45 The Vineyard Planning Changes

Date: August 2024
Doc No. 5008

Revision G

Since activating the planning permission (ref 19/0954/VRC) the scheme has undergone both a stage 3 design review and stage 4 design development. This document seeks to present the design updates with a view to substituting the existing planning drawings with an updated set to maintain the completeness of the consent, for the avoidance of doubt and in the interests of proper planning. The design updates have been made for the following reasons:

Drawing Title
GROUND FLOOR PLAN PROPOSED

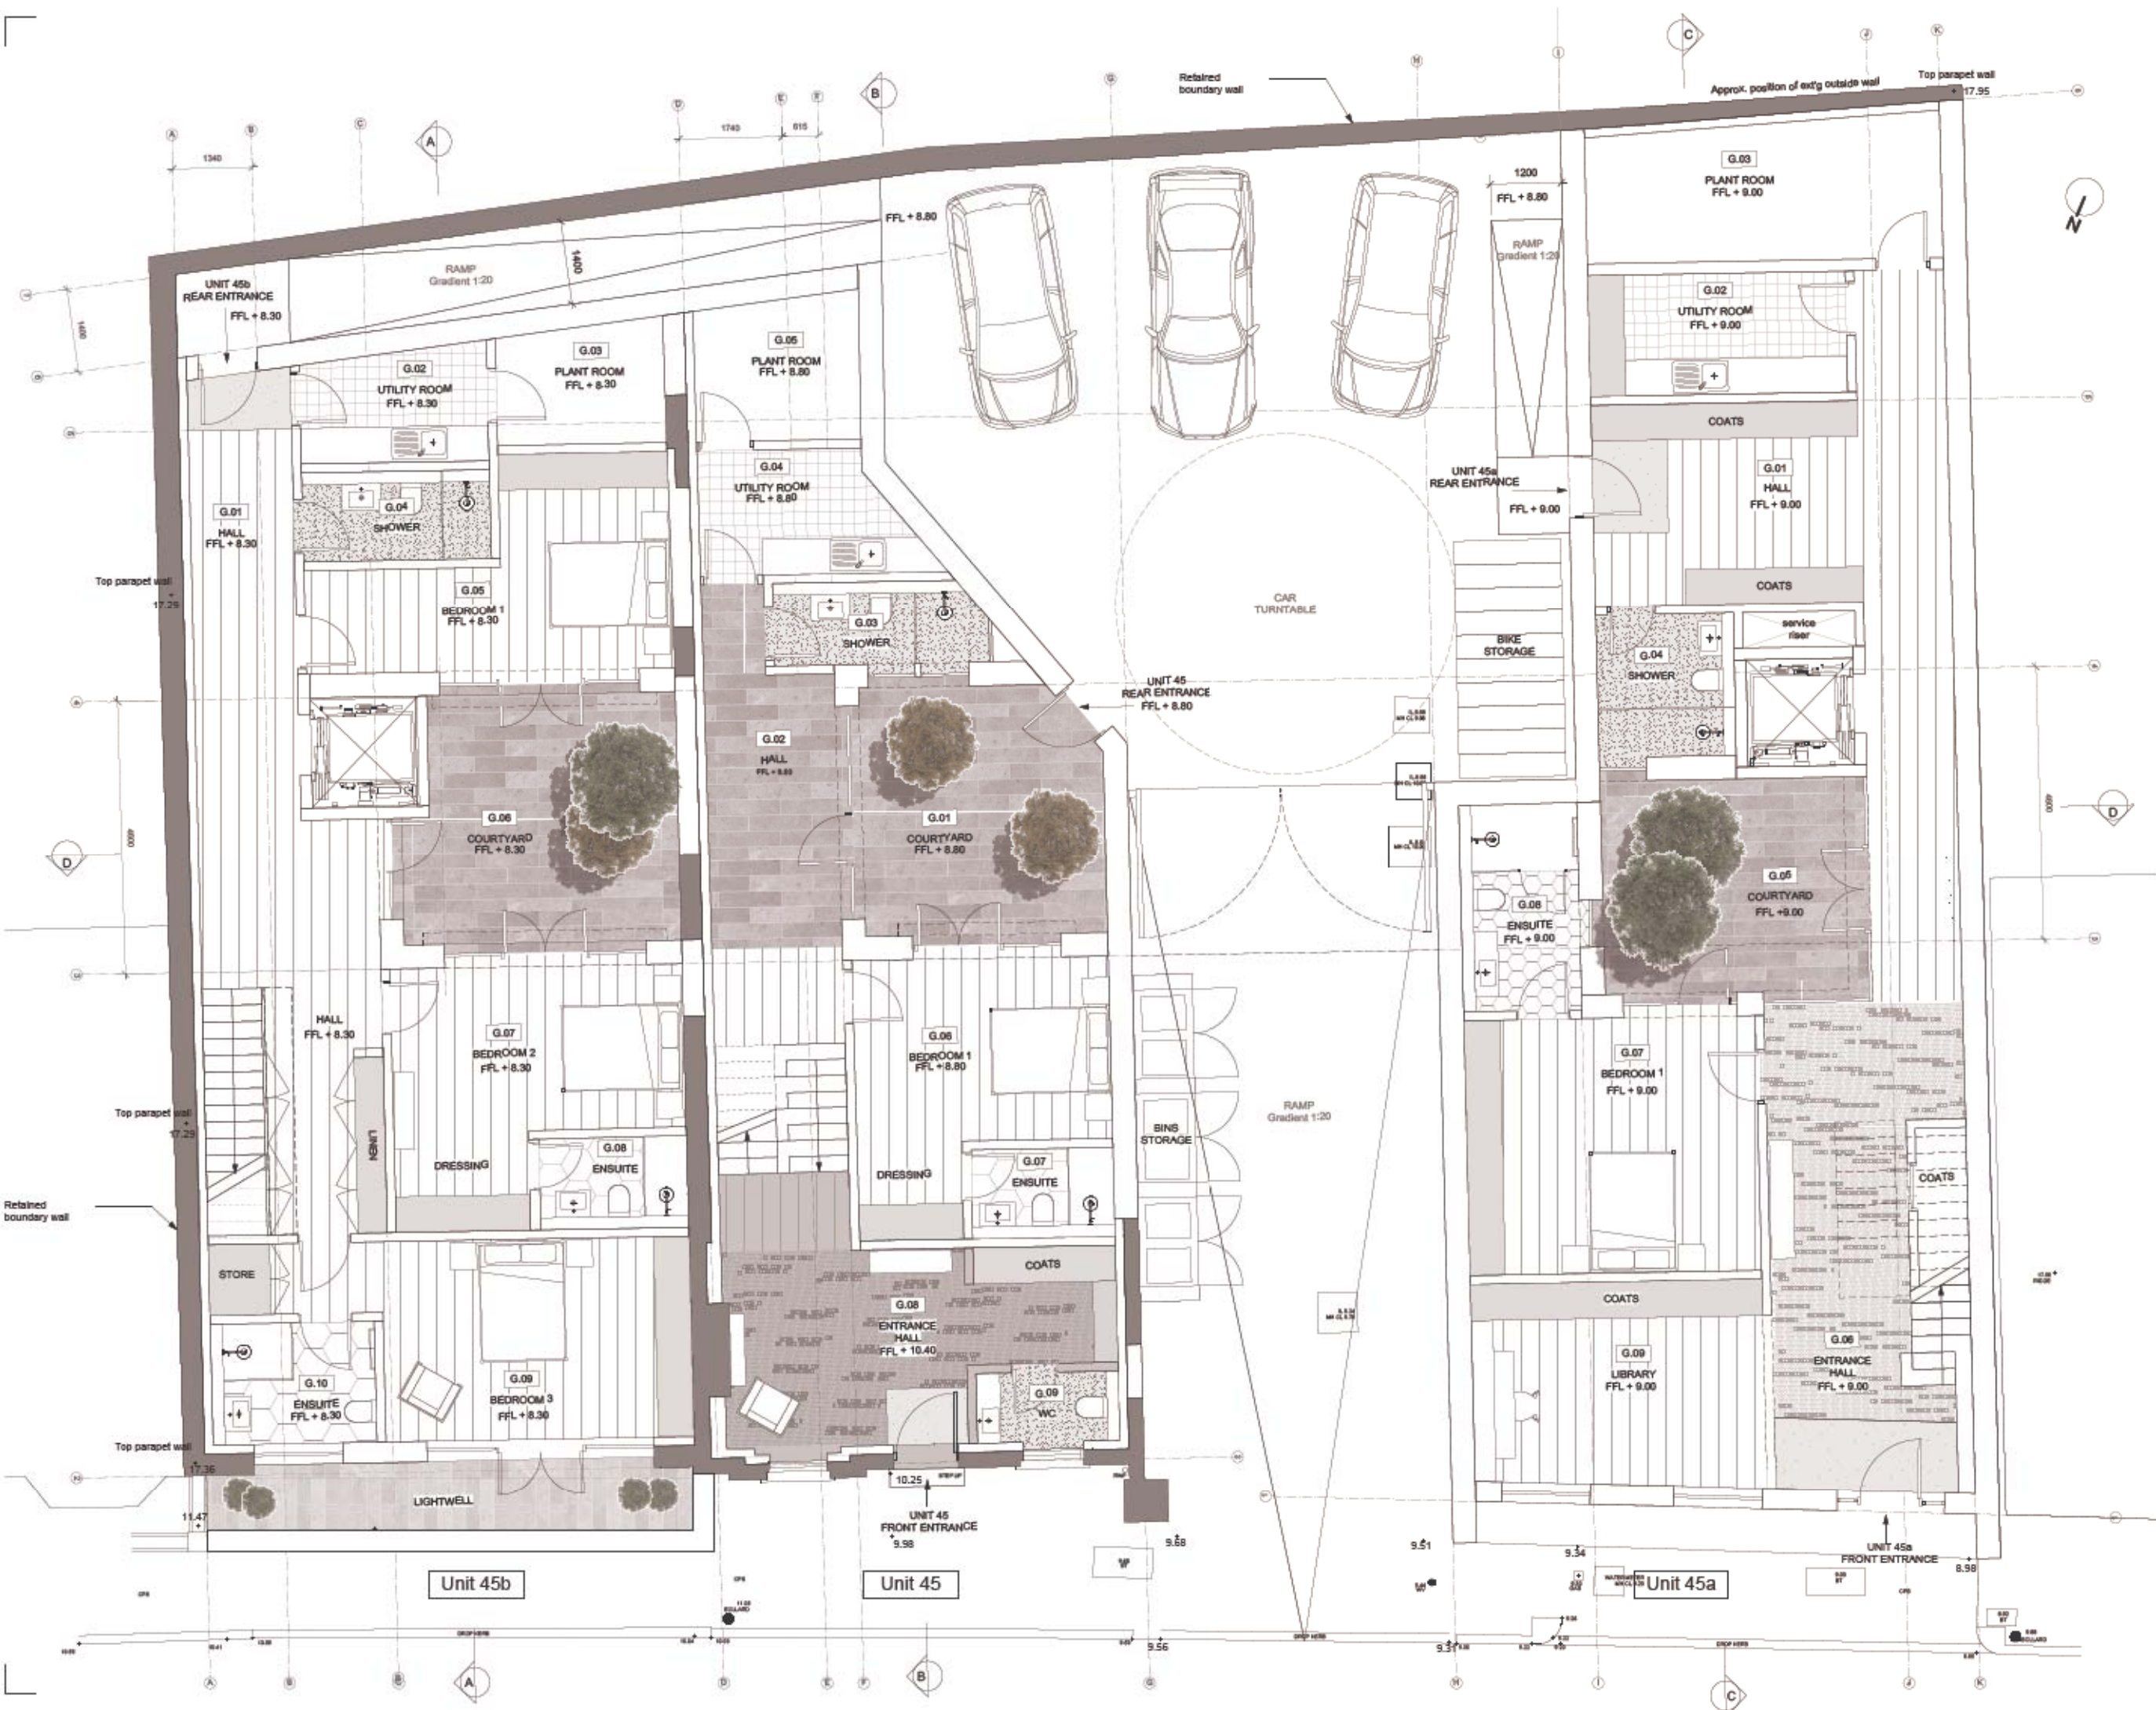
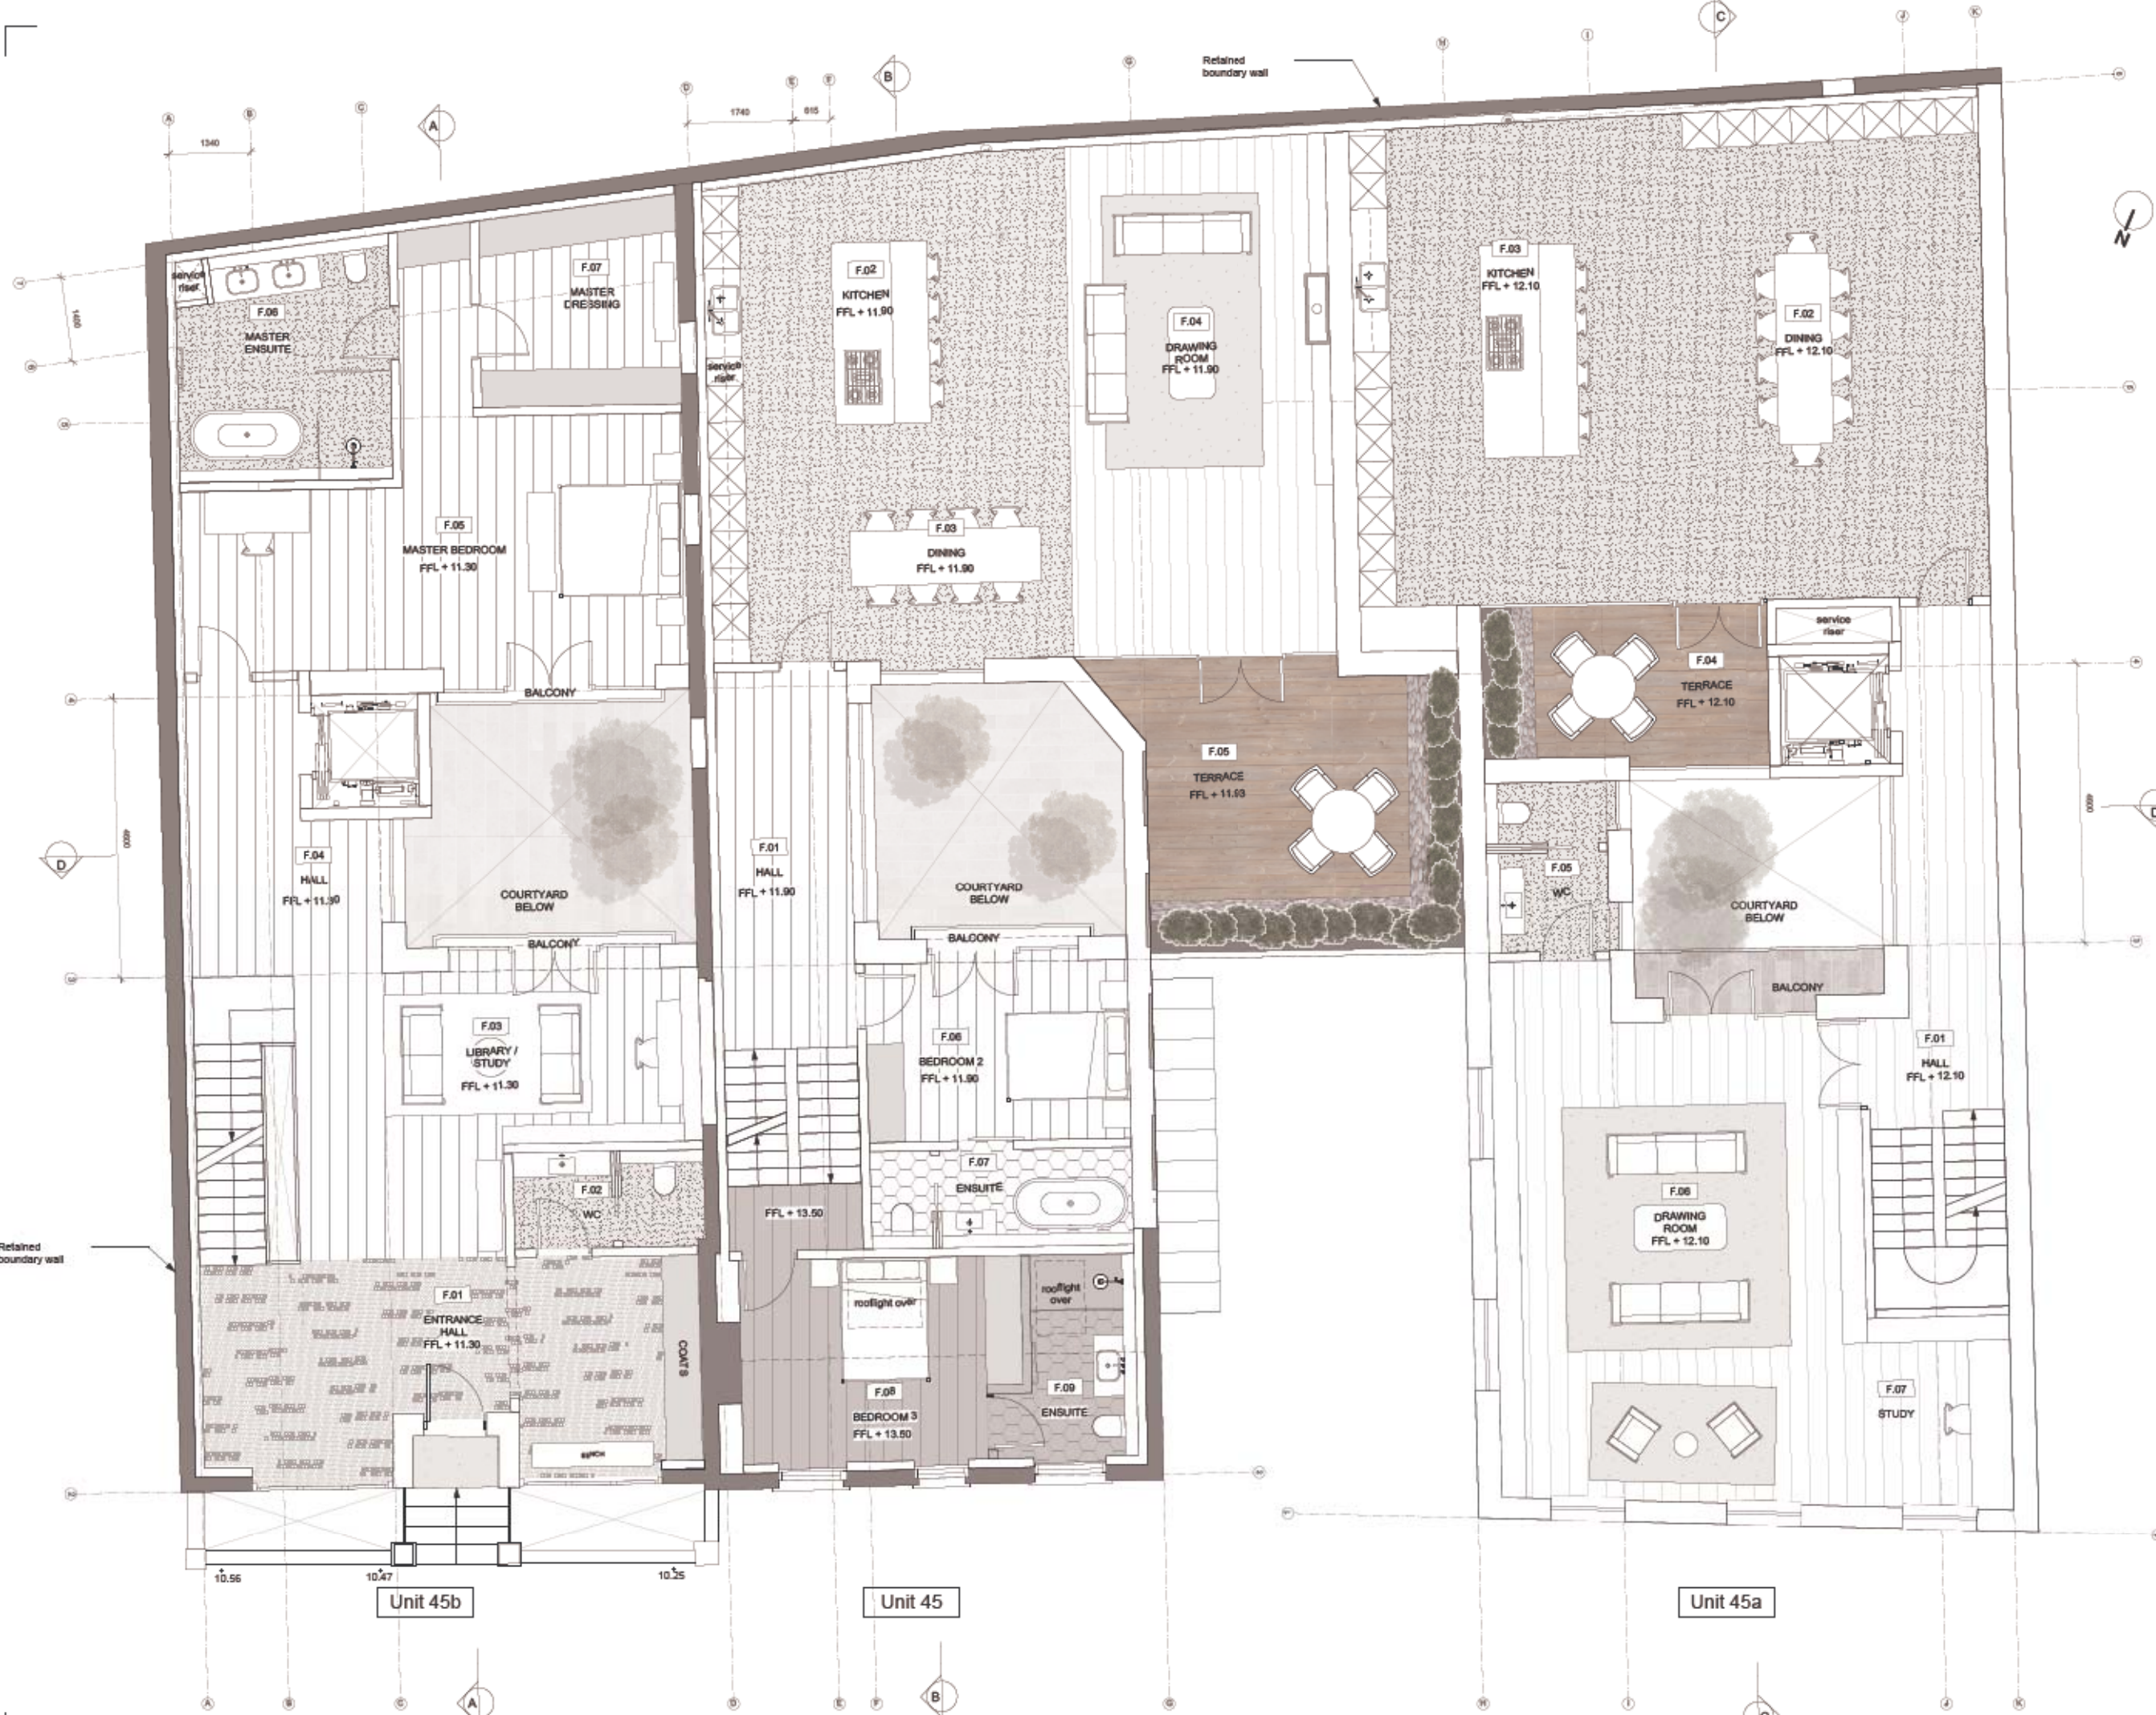
It is proposed to distribute the bicycle storage closer to each unit entrance within the car park and retain a central guest store (as per dwg 0800). Provision for 10 cycles is maintained.

It is proposed to arrange the levels in the car park so that the ramp into 45a can be omitted (as per dwg 0800), whilst maintaining step-free access.

Drawing Title
SECOND FLOOR PLAN PROPOSED

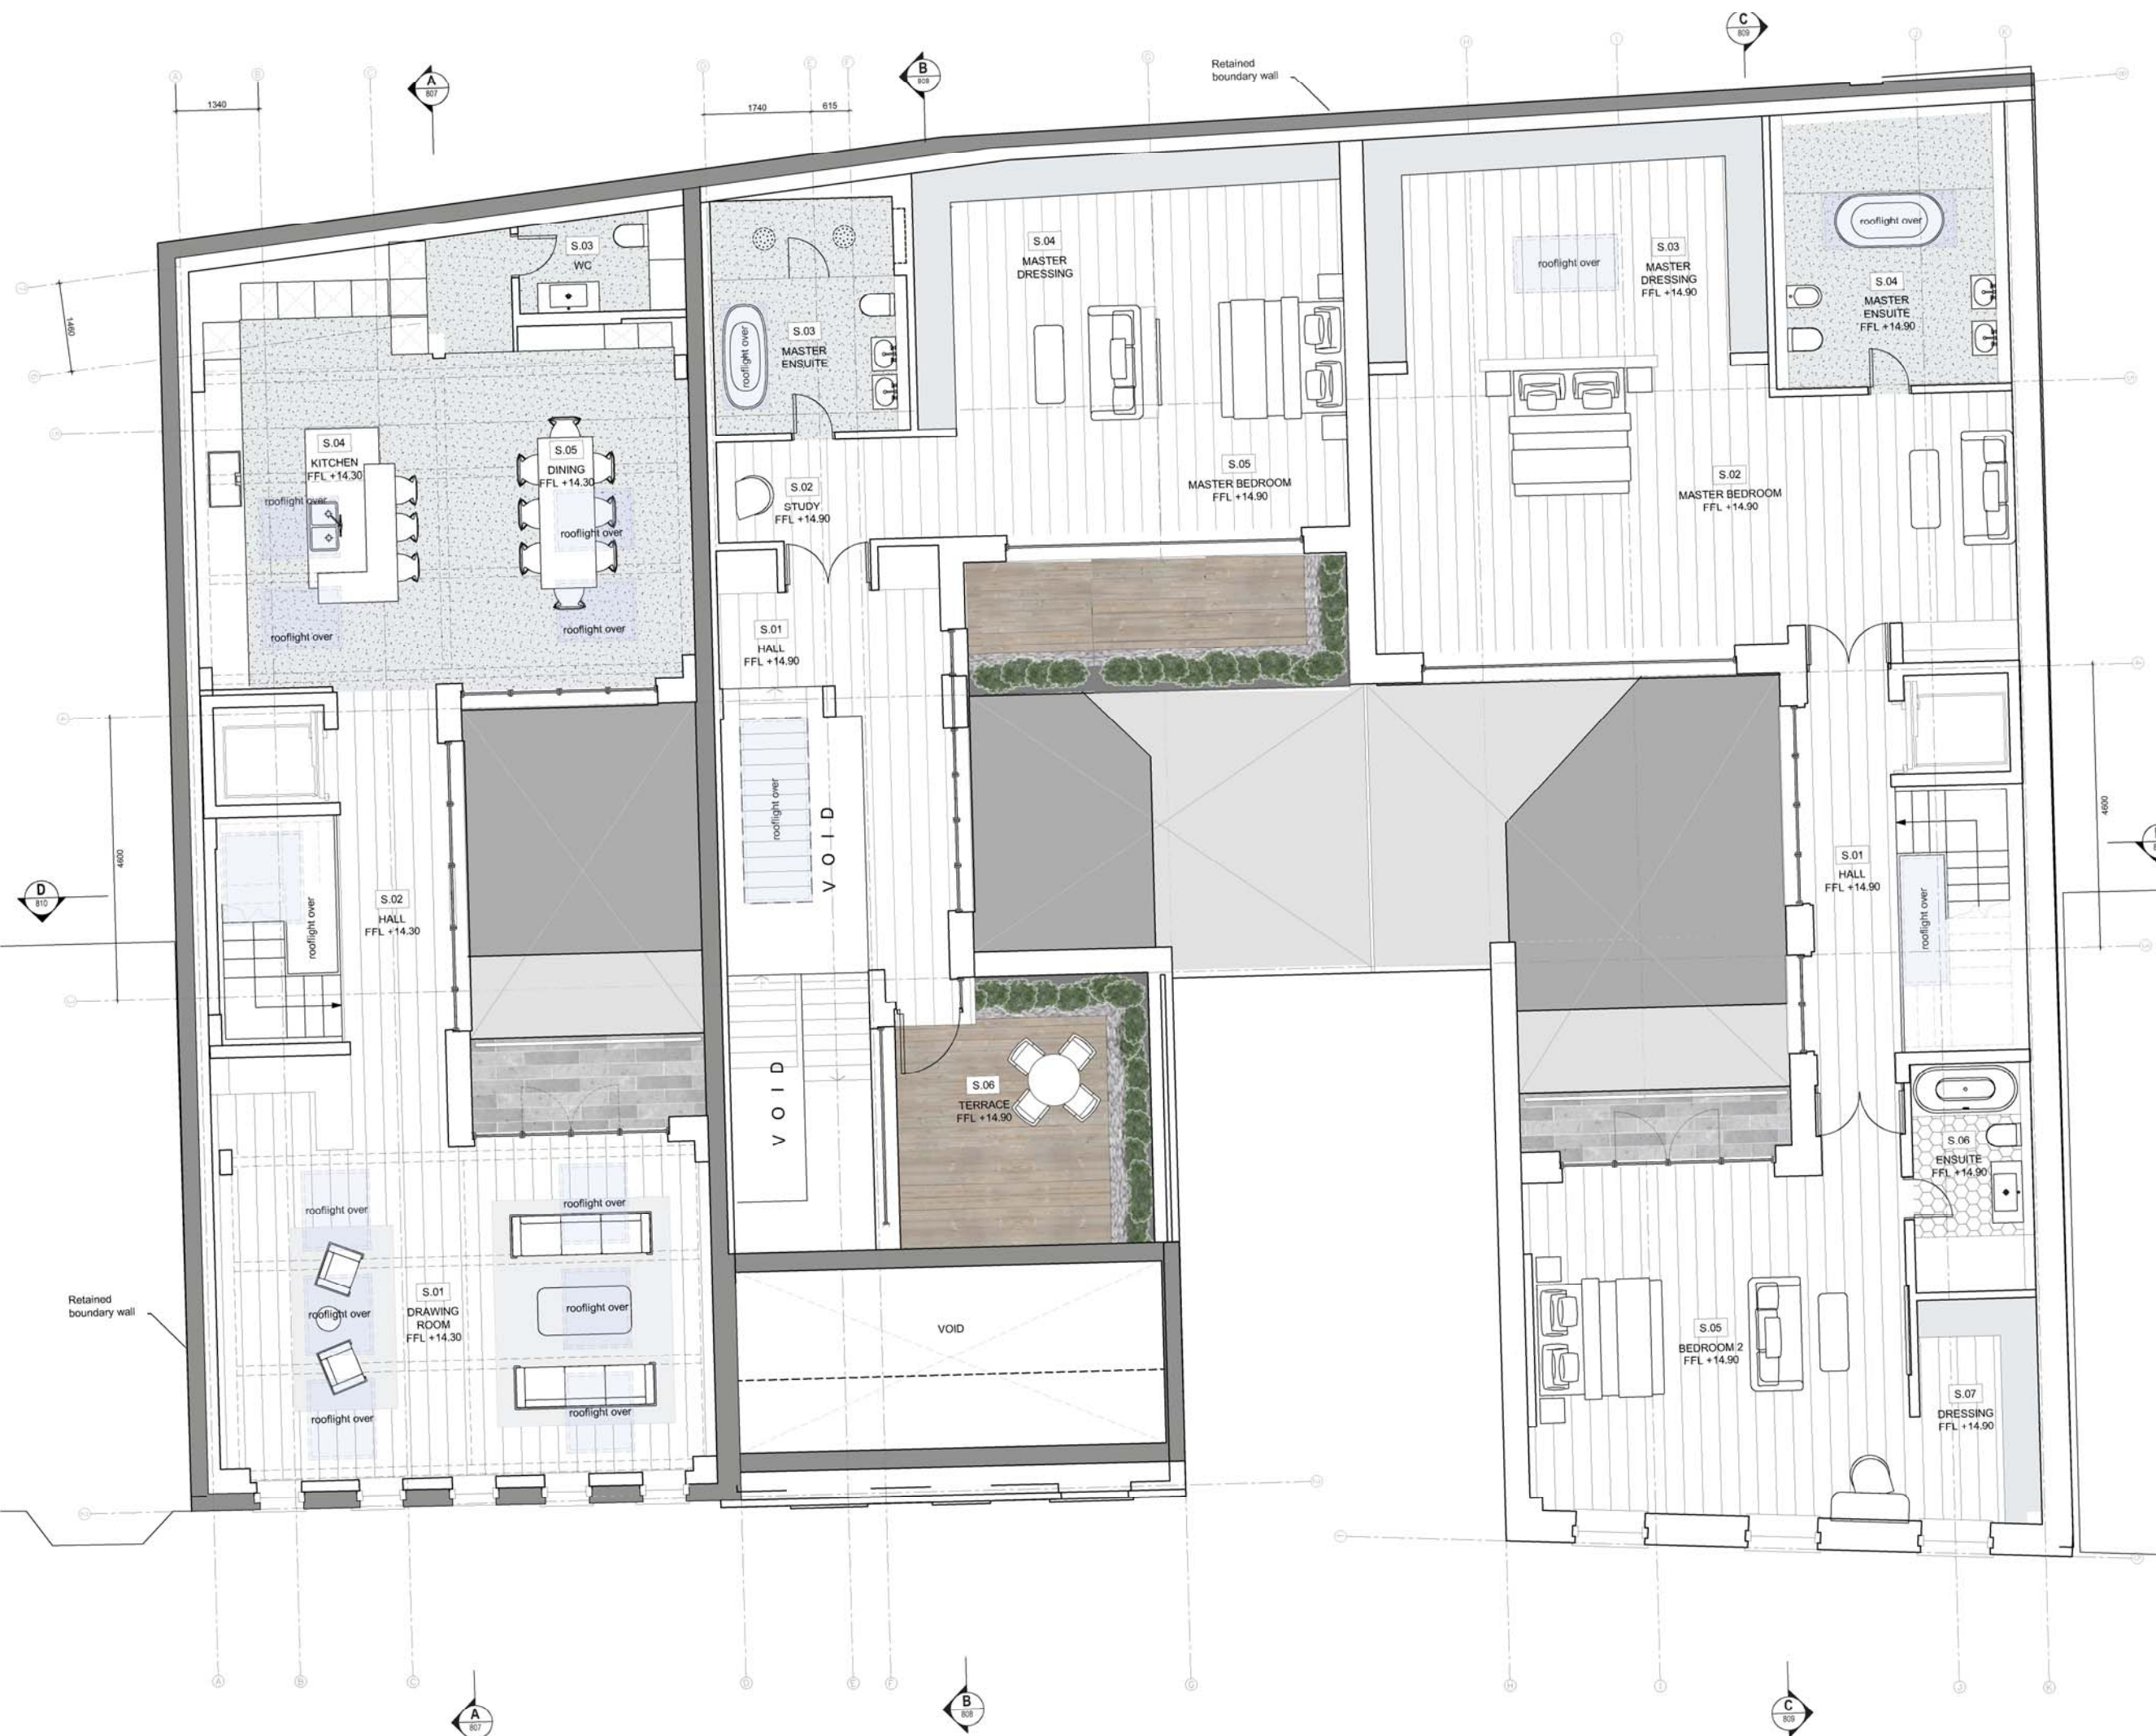
The substandard bedroom sizes in unit 45 (bedroom 1 and 2 on dwgs 02-ST-100 & 102) have been improved through rearrangement. All bedrooms now exceed the nationally described space standard.
